Application No. 09/978,528
Response dated February 15, 2005
Reply to Office Action of December 3, 2004

Amendments to the Drawings

Fig.5

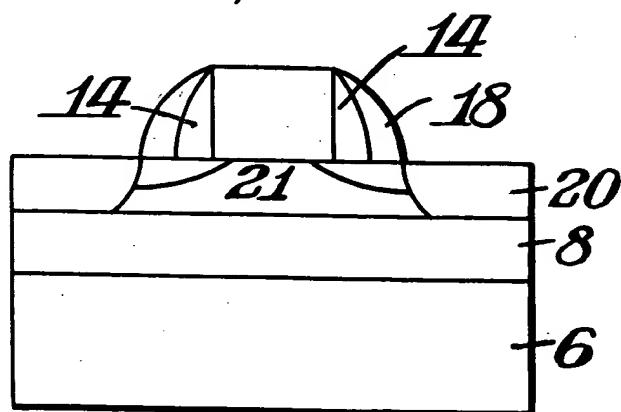
The attached annotated sheets, attached as Exhibit A herewith, include the original drawing sheet containing Figs. 2-7, with changes to these drawings shown in red ink. The changes are extending the lead line for reference numeral "14" in Fig. 5, and adding reference numeral "17" to Figs. 6 and 7. A replacement drawing sheet that includes Figs. 2-7 is also attached as Exhibit A. This attached replacement sheet replaces the original drawing sheet including Figs. 2-7.
